ADDENDUM #04

DATE:	September 29, 2023	PROJECT NO.:	Project # 20229080 CRSA Project # 21-031
TO:	Gramoll Construction 155 S. 750 W. North Salt Lake, UT 84054	PROJECT:	Rio Grande Depot Seismic 300 S. Rio Grande St. SLC, UT 84101

This Addendum forms a part of the Contract Documents and modifies the original Bid Documents dated October 3, 2022 as noted below. Acknowledge receipt of this Addendum in the space provided on the Bid Form. Failure to do so may subject the Bidder to disqualification.

D3 AE402 GRANDE LOBBY - MEZZANINE 244 - NORTH AND SOUTH
1/4" = 1'-0"

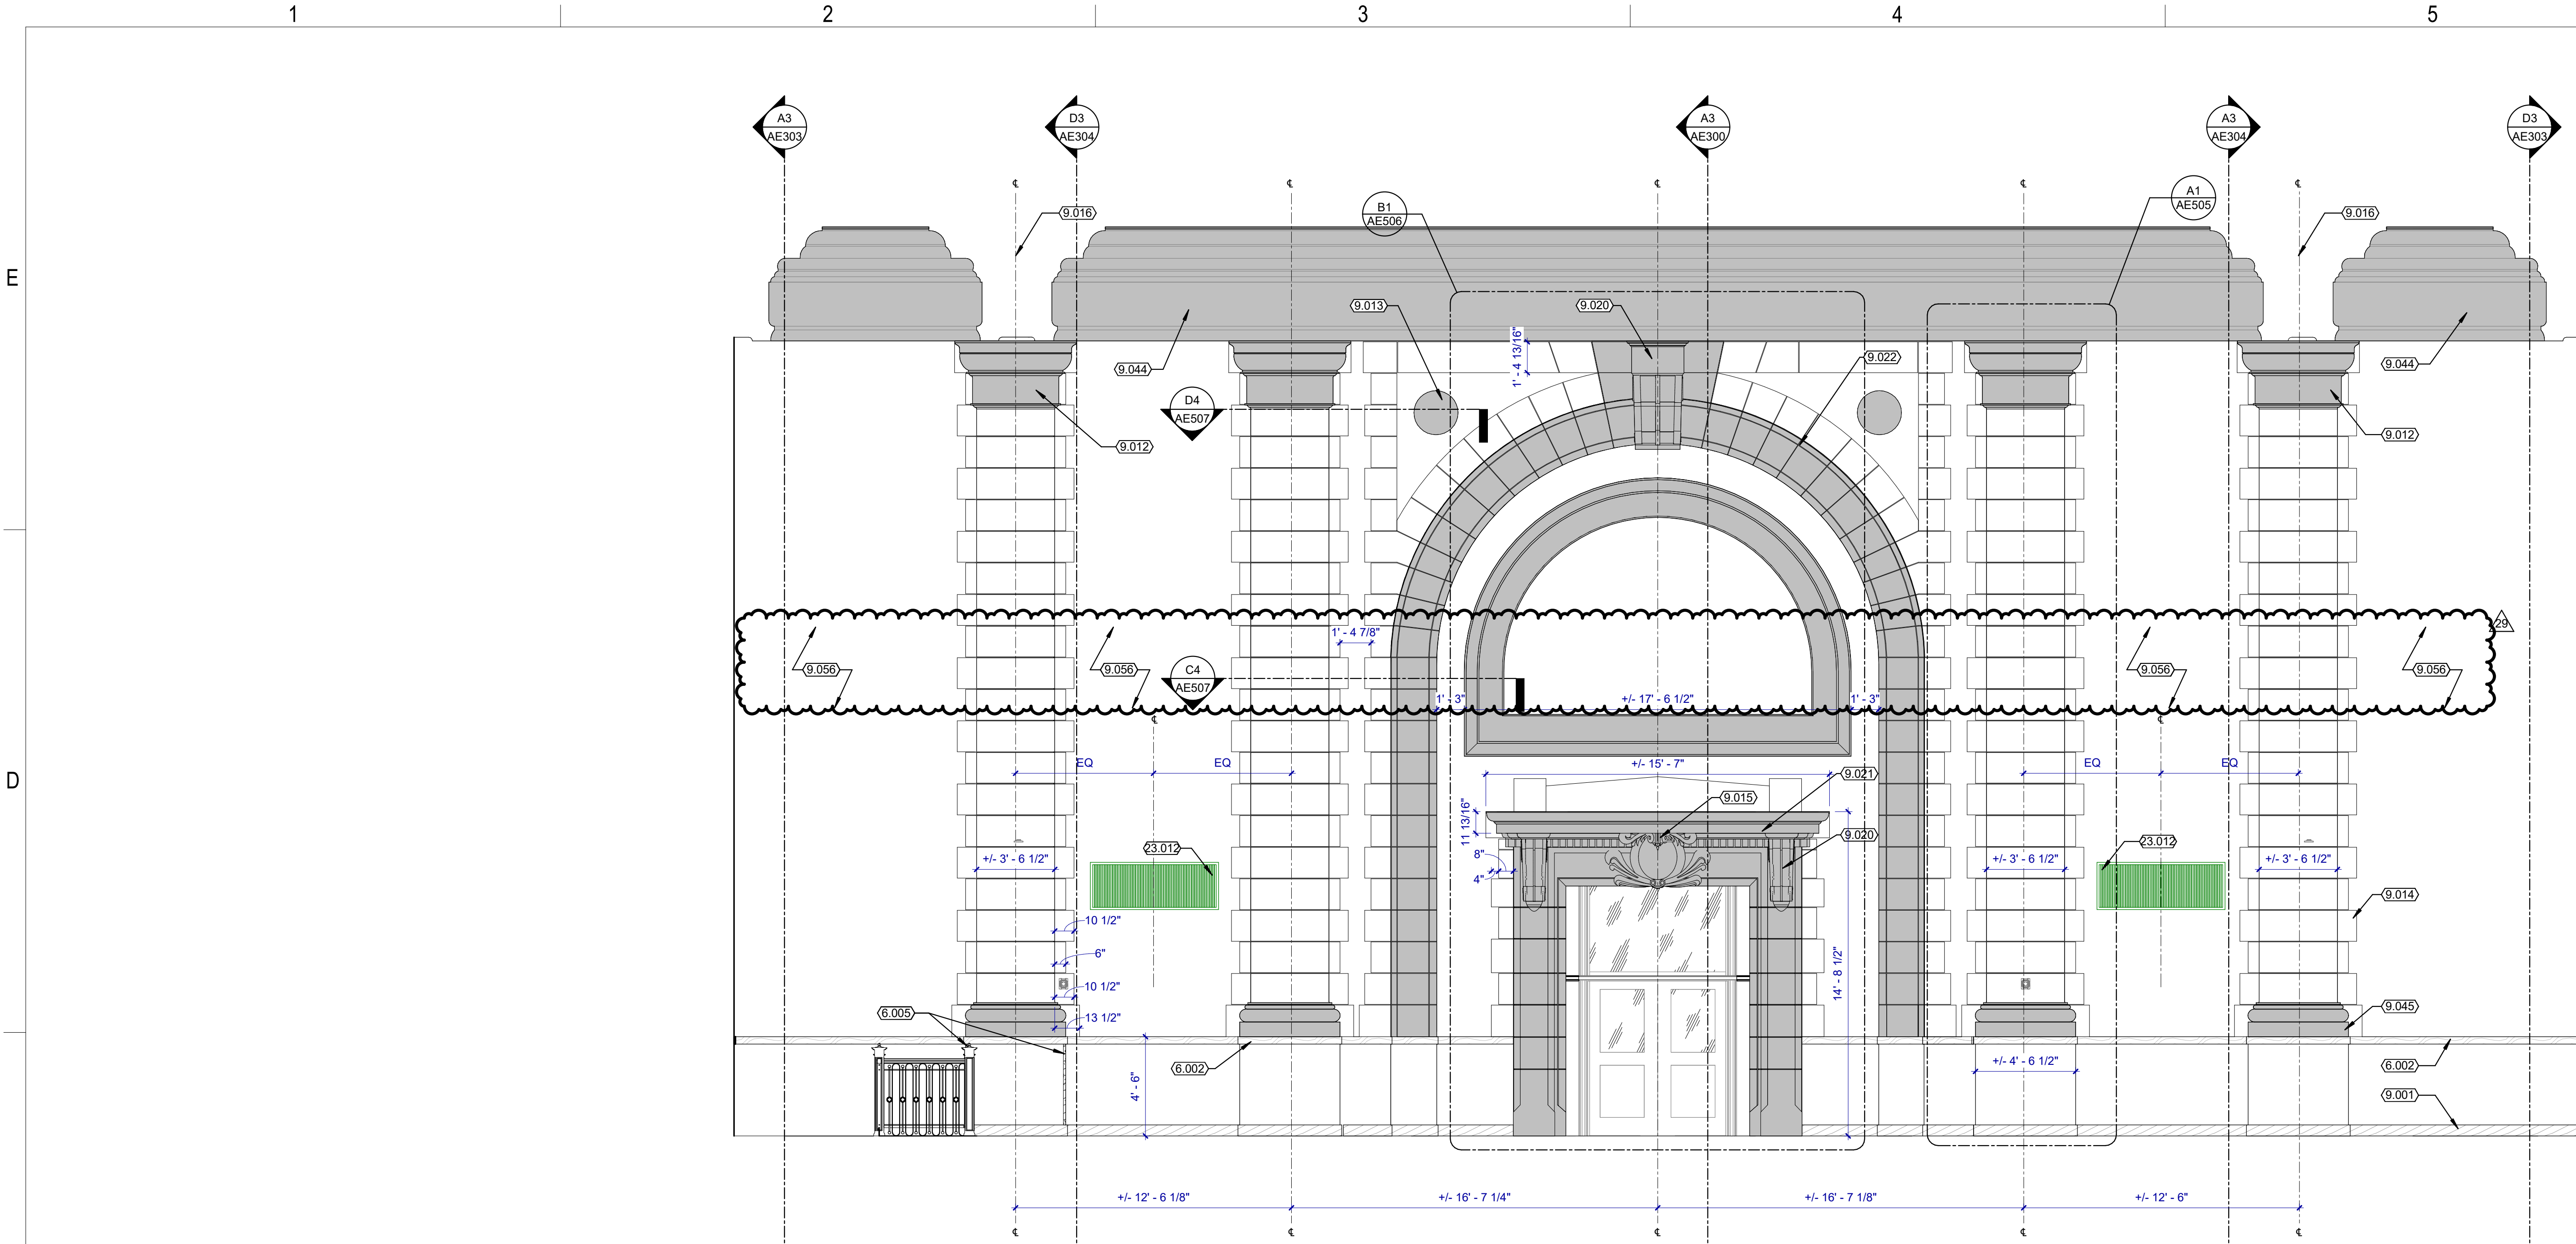
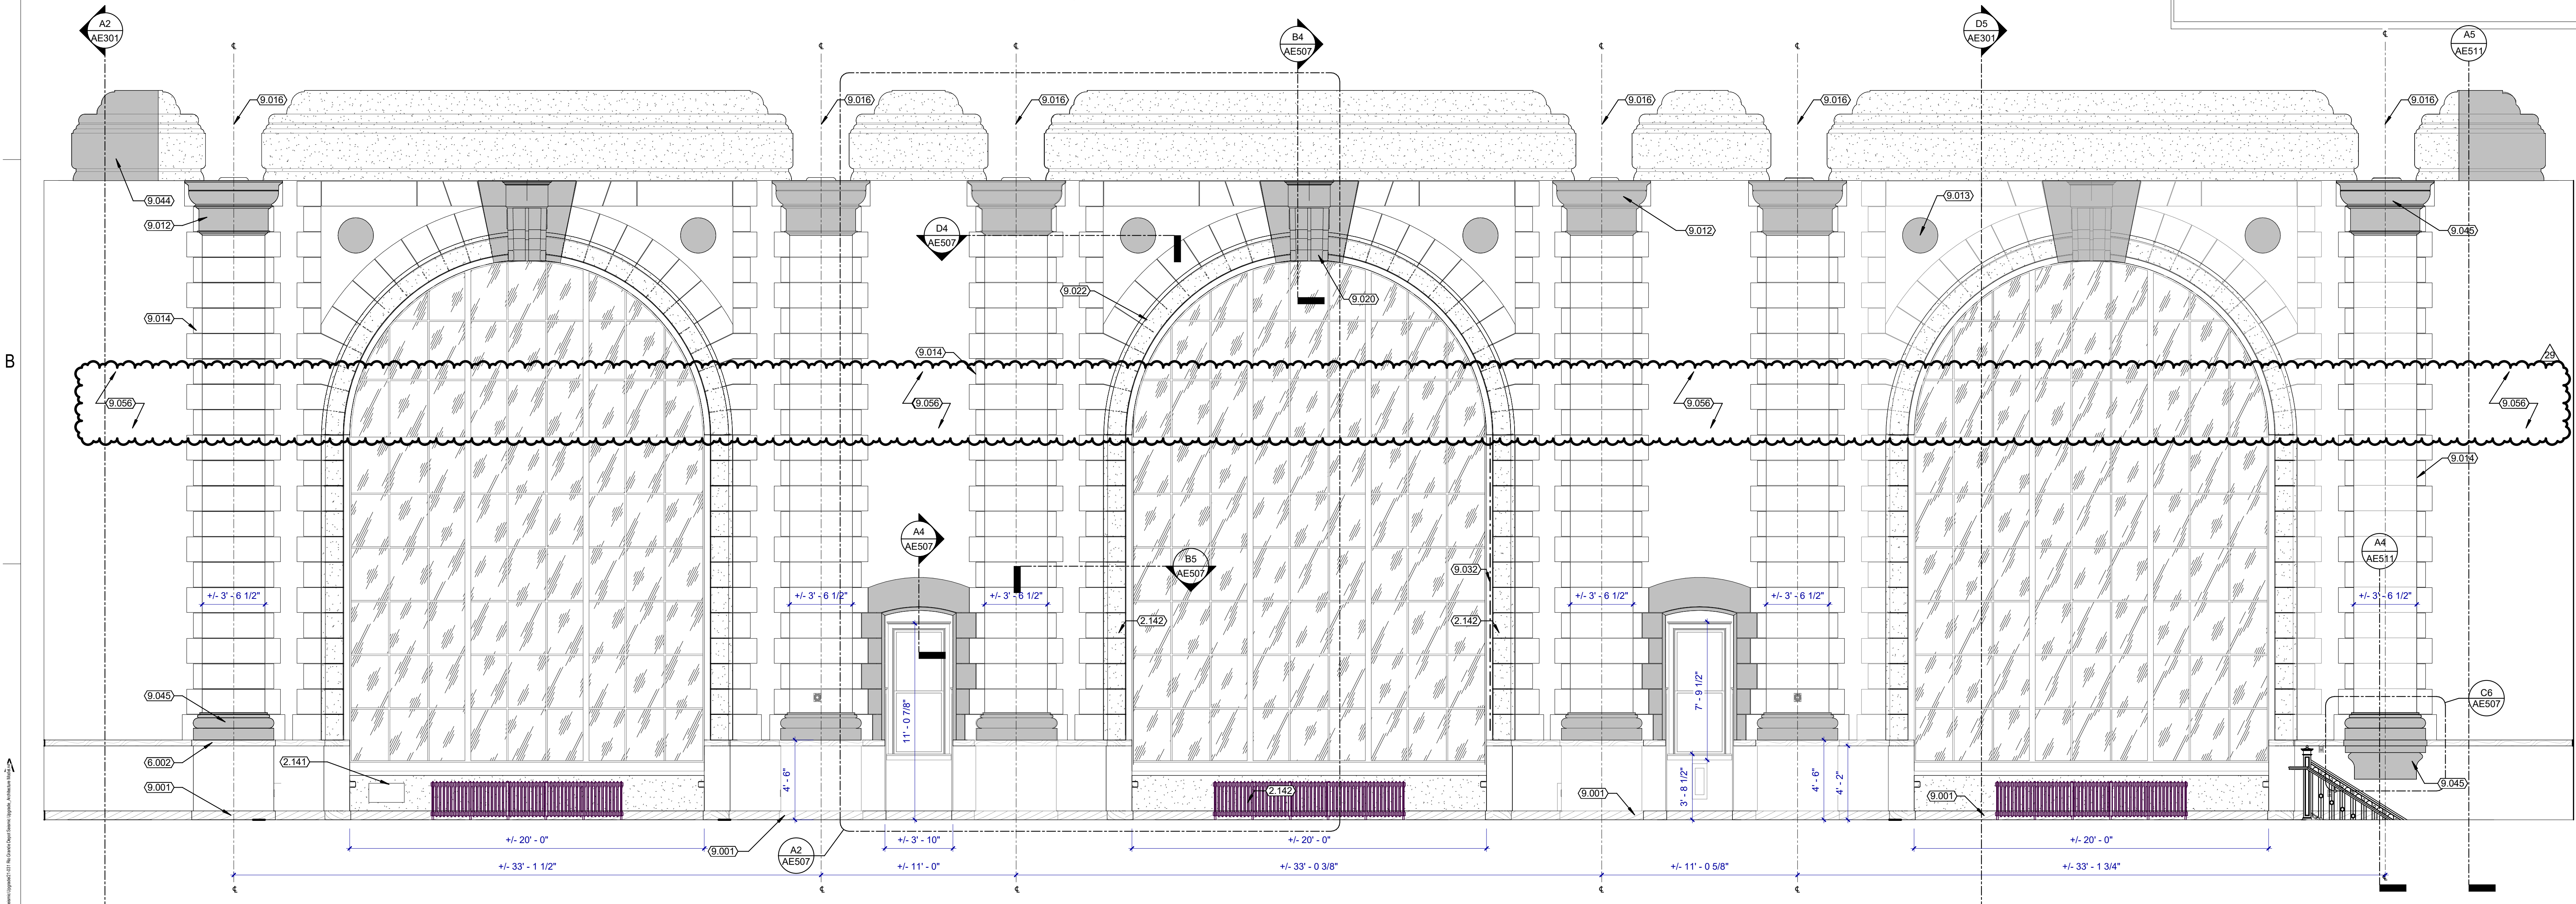
VI-4 AE402: Added veneer plaster keynote to elevations.
